OYSTER CREEK NUCLEAR GENERATING STATION, UNIT NO. 1

AMENDMENT TO PROVISIONAL OPERATING LICENSE

Amendment No. 16
License No. DPR-16

ATTACHMENT TO LICENSE AMENDMENT NO. 16

FUEL CLADDING INTEGRITY SAFETY LIMIT

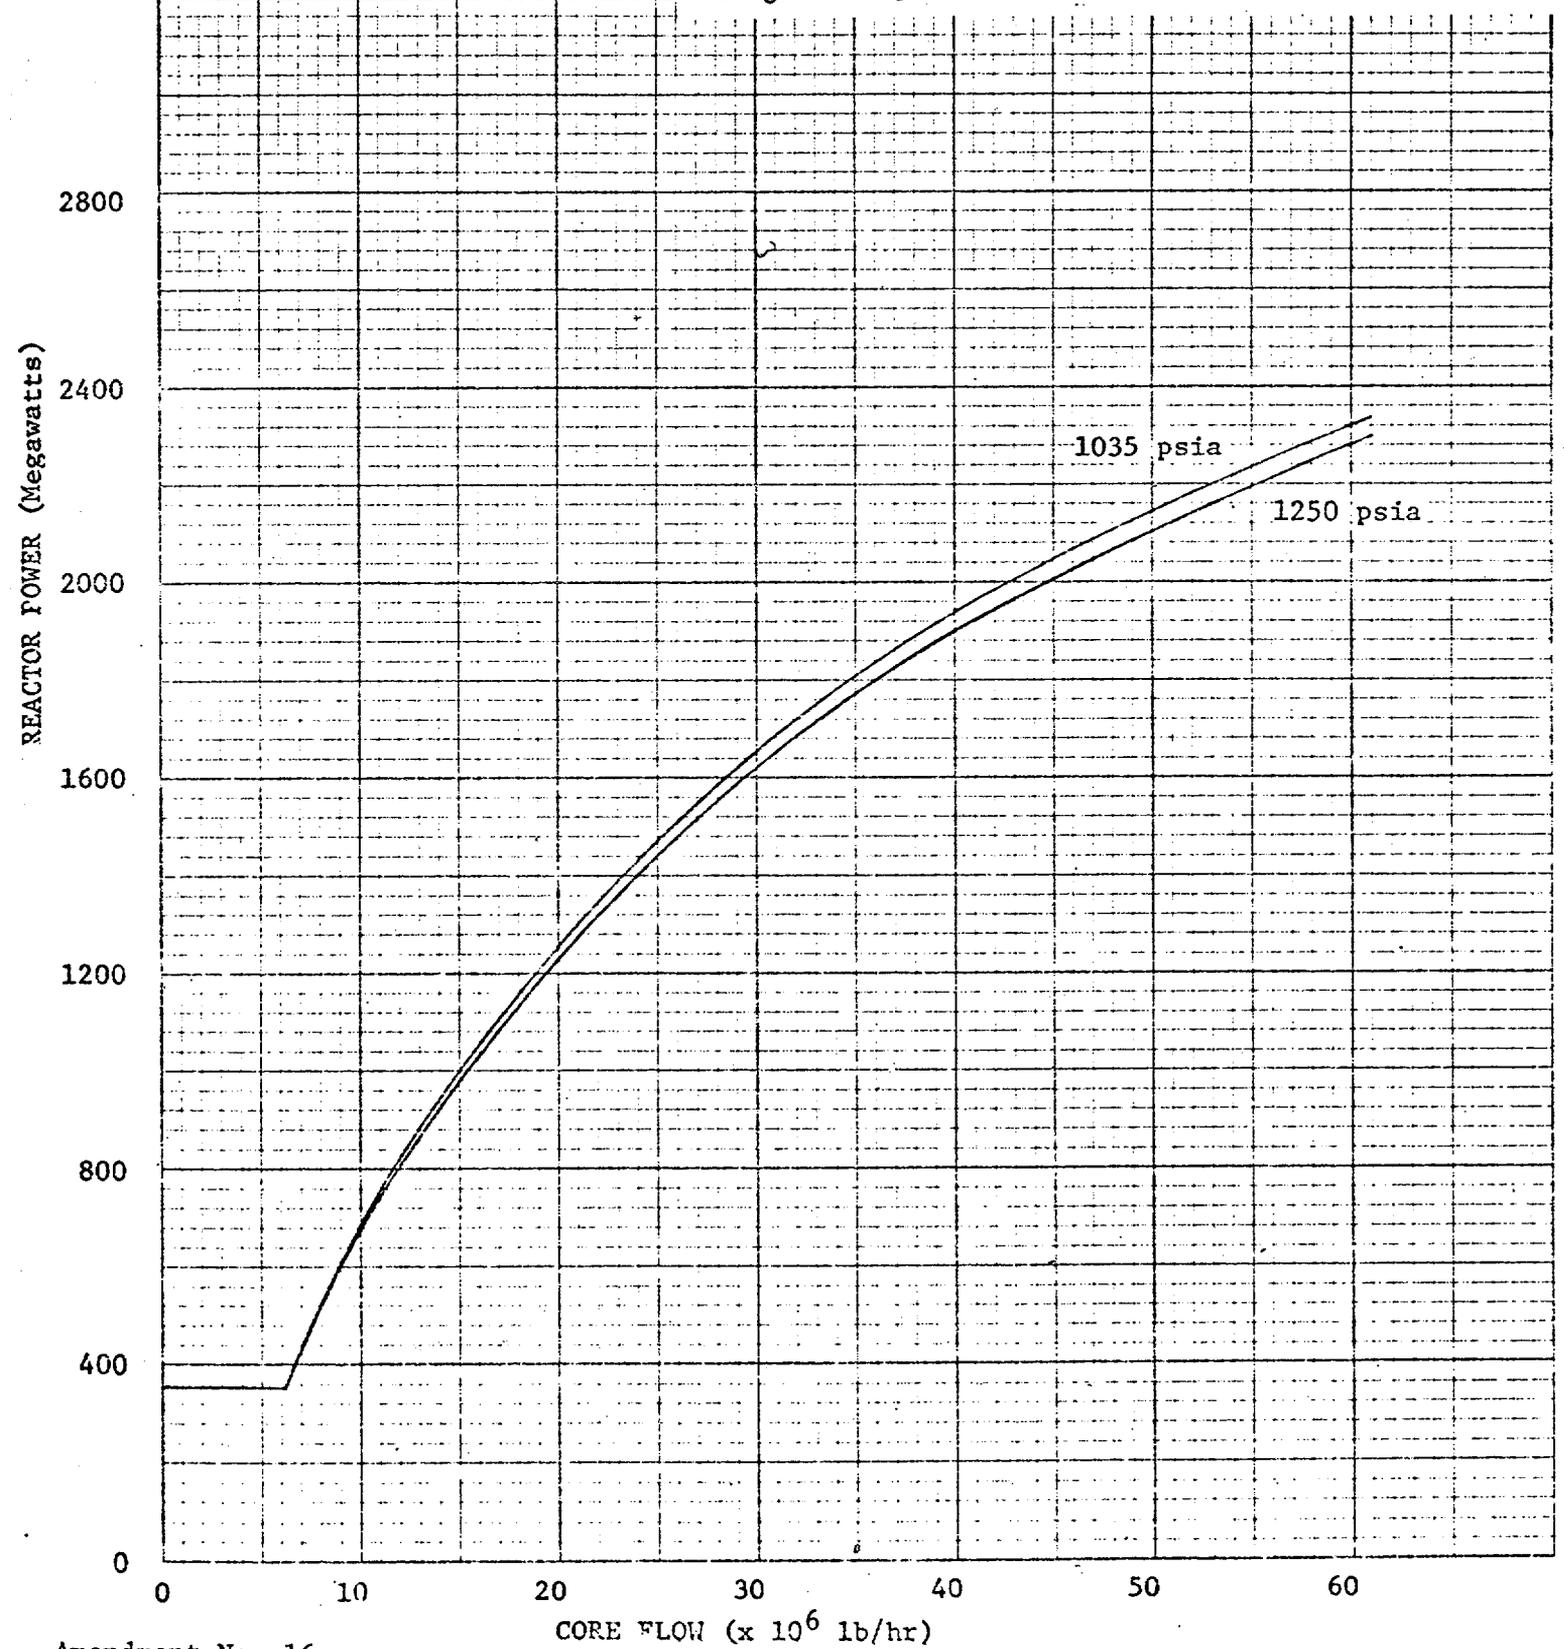
The safety limit curves shown in Figure 2.1.1 represent conditions which assure with better than 95 percent confidence a 95 percent probability of avoiding a critical heat flux occurrence. The critical power value was determined using the design basis critical power correlation given in reference 1. The operating range with MCPR >1.32 for 7 x 7 fuel and 1.34 for 8 x 8 fuel is below and to the right of these curves.

The safety curve of Figure 2.1.1 is based on total peaking factors of 2.74 for fuel types IIIE and IIIF; 2.80 for fuel types I, II, and III; and 2.78 for 8 x 8 fuel. These curves are to be adjusted downward (by the equations shown in Specification 2.1.A.2) in the event of higher peaking factors. Also, to insure MCPR's greater than 1.32 for 7 x 7 fuel and 1.34 for 8 x 8 fuel during expected transients, neutron flux, scram and control rod block settings must be correspondingly reduced. The equations describing these setpoints make allowance for peaking factors greater than 2.74, 2.80, or 2.78 respectively for the fuel types listed above by reducing the setpoints at rated neutron flux by the ratio of PF_0 to PF .

FIGURE 3.10-1

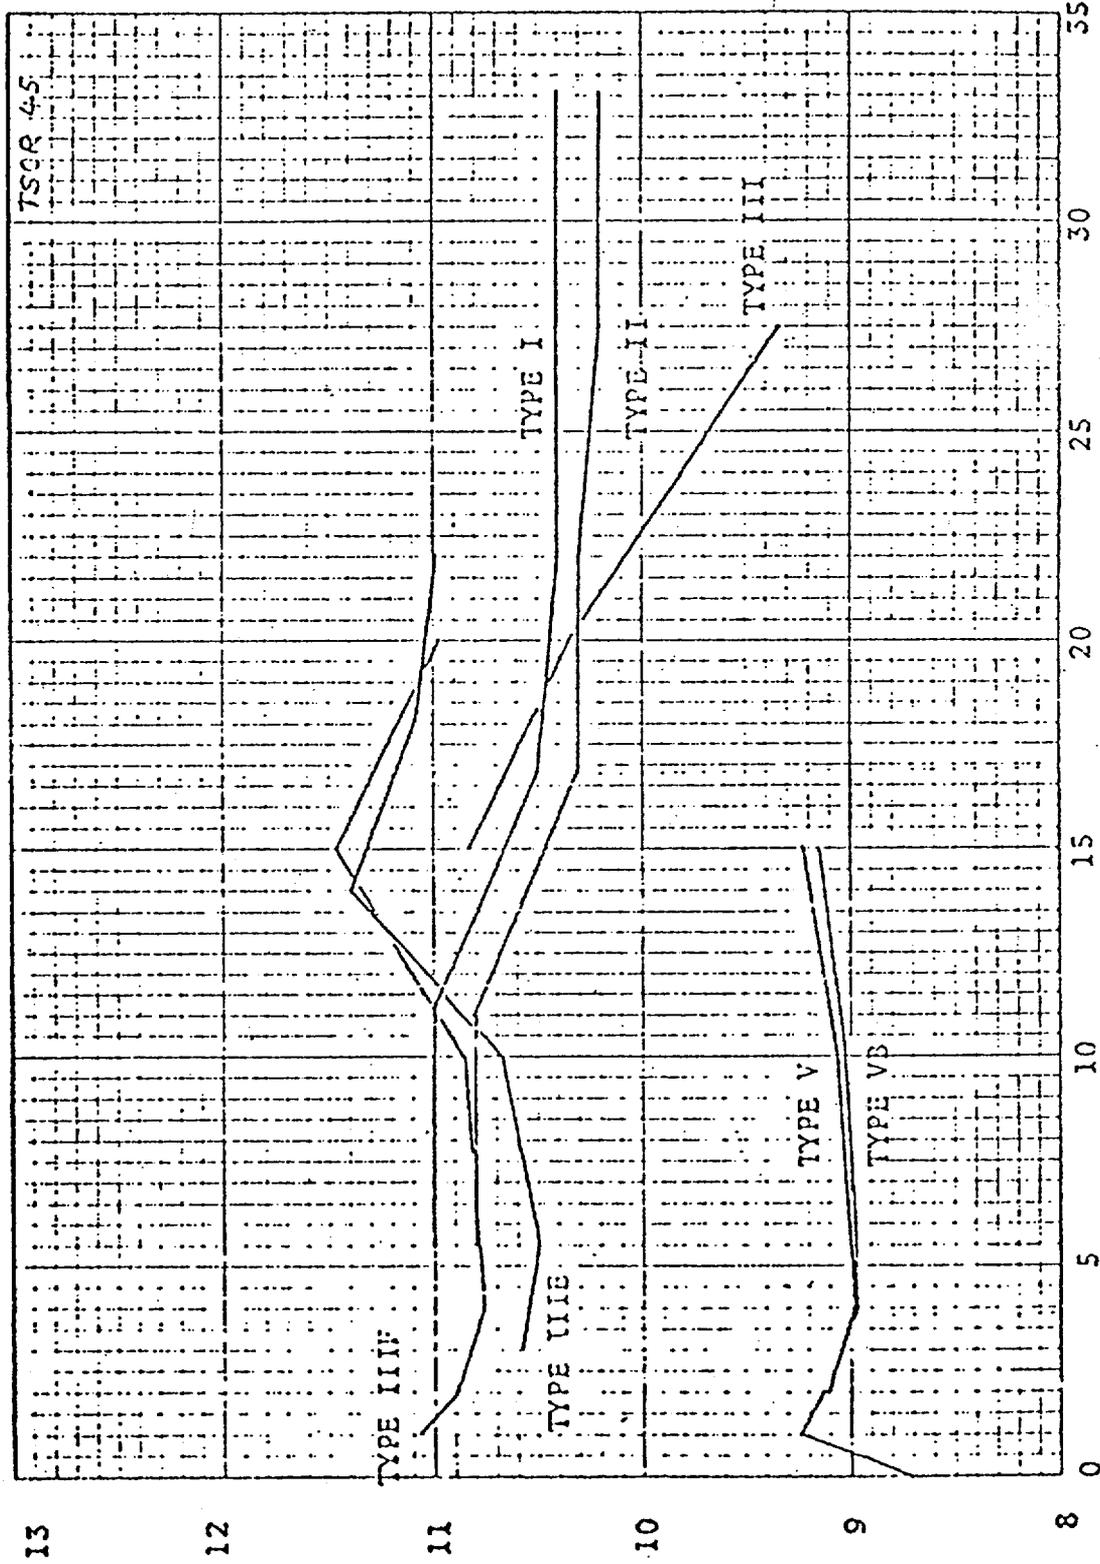
With respect to the increased MAPLHGR for types V and VB fuel shown in revised figure 3.10-1 of the technical specifications, the staff has concluded that the Exxon Nuclear Company Topical Reports "Spray Cooling Heat Transfer Phase 1 Test Results ENC - 8x8 BWR 60 and 63 Active Rods" and Supplements dated September 1975, and October 1975 that were approved by NRC on May 17, 1976, ⁽¹⁾ are an acceptable reference to justify use of the full "Appendix K" specified spray coefficients for ENC 8x8 fuel in the Oyster Creek reactor.

We agree with the Jersey Central Power and Light Company (JCP&L) statement that use of the new spray coefficients will not change the worst break location, size, or associated single failure ⁽²⁾. Therefore, reanalysis of the limiting 0.50 ft² break at the listed exposures ⁽³⁾ constitutes an acceptable ECCS analysis meeting all requirements of Appendix K to 10 CFR 50, and we approve operation of the Oyster Creek Reactor up to the Maximum Average Planar Linear Heat Generation Rate (MAPLHGR) limits resulting from those reanalyses utilizing the full Appendix K specified spray coefficients as shown in revised figure 3.10-1 of the technical specifications.

MAXIMUM ALLOWABLE AVERAGE PLANAR
LINEAR HEAT GENERATION RATE
